Access Compliance Report

Public Rights-of-Way (Curb Ramps)

Intersection ID: 21744	Main Street: BERRY RIDGE RD	Cross Street: RENFROW LN	Location: SW
ADA ID: 602310F45EEB	Ramp Type: BlendTrans2	Initial Pass/Fail: Fail	Overall Compliance: No
Severity Score: 1.25			
Codes/Mitigation Info/Possible Solution		Field Measurements/Component Compliance

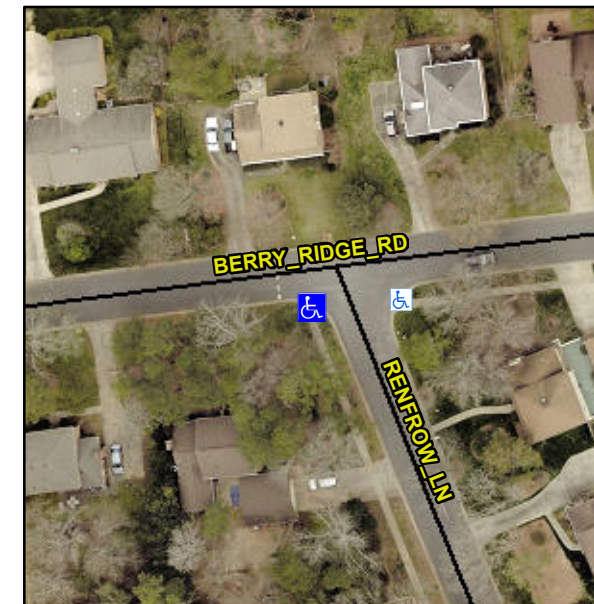
Not Found, R304.5.3

Compliance	Description	Data	Compliance	Description	Data
N/A	Ramp Length (in)	55.0	Yes	BlendTrans Slope (%)	2.7
Yes	Ramp Width (in)	48.0	No	BlendTrans XSlope (%)	2.4
N/A	Flare Type LT	N/A	N/A	Flare Type RT	N/A
N/A	Flare Slope LT (%)	N/A	N/A	Flare Slope RT (%)	N/A
N/A	Flare Traversable LT?	N/A	N/A	Flare Traversable RT?	N/A
N/A	Landing Length (in)	N/A	N/A	DWS Provided?	N/A
N/A	Landing Width (in)	N/A	N/A	DWS Contrast?	N/A
N/A	Landing Slope (%)	N/A	N/A	DWS Length (in)	N/A
N/A	Landing X Slope (%)	N/A	N/A	DWS Full Width?	N/A
N/A	Landing Curb? (Y/N)	N/A	N/A	DWS Offset (in)	N/A
N/A	Shared Landing?	N/A			
N/A	Gutter Ponding?	N/A	N/A	Gutter Slope (%)	N/A
N/A	Gutter Lip Ht (in)	N/A	N/A	Gutter X Slope (%)	N/A
N/A	Painted X Walk1?	No	N/A	Painted X Walk2?	No
	X Walk 1 Direction	To E		X Walk 2 Direction	To N
	X Walk 1 Width (in)	N/A		X Walk 2 Width (in)	N/A
	X Walk 1 Slope (%)	3.5		X Walk 2 Slope (%)	2.3
	X Walk 1 X Slope (%)	0.1		X Walk 2 X Slope (%)	3.4

N/A	Ramp inside XWalk1?	N/A	N/A	Ramp inside XWalk2?	N/A
	Road Slope (%)	0.2		Clear Space?	N/A
	Road X Slope (%)	4.4	N/A	Clear Space to XWalk (in)	N/A
N/A	Any Obstructions?	N/A	N/A	Storm Grate/Utility Hazard?	N/A
	Obstruction Type			Storm Grate/Utility Type	
		N/A			N/A
			Yes	Surface Condition? (G/P)	Good
			No	Curb Slope (%)	11.7

Remove & Replace Curb Ramp With Two New Directional Ramps or Equivalent.
